LCAX4-56H-L
Copper Lug - One-Hole, Standard Flex Barrel, 45° Angle Tongue

SCALE N/A DRAWING NO / CAD FILE LCAX4-56H-CUST

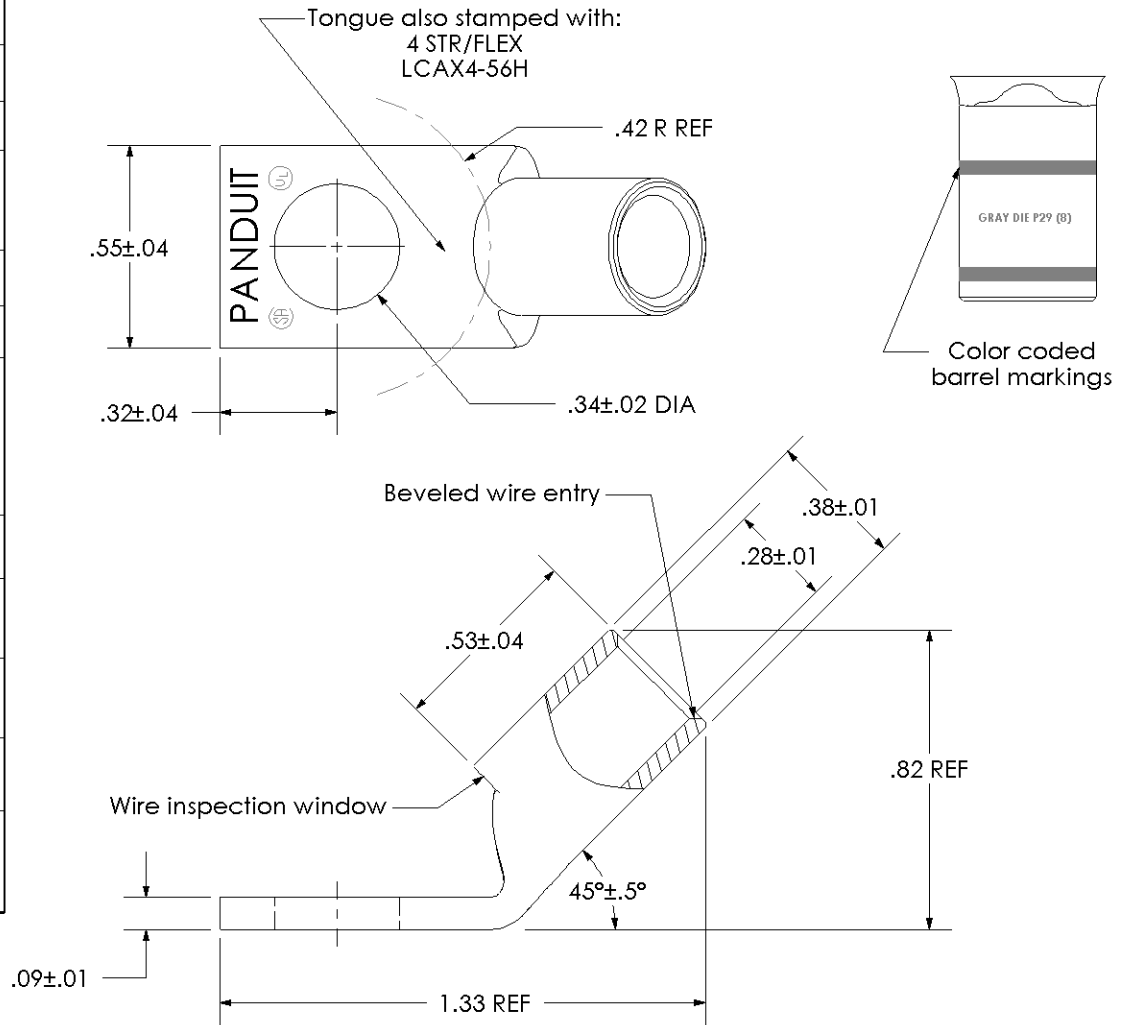
01	3/04	KLFU	TLCO	WIRE SIZE WAS: 4 STR/FLEX ADDED 3 & 5 FLEX, LOCOMOTIVE ONLY * NOTE	11610
REV	DATE	BY	CHK	DESCRIPTION	ECN
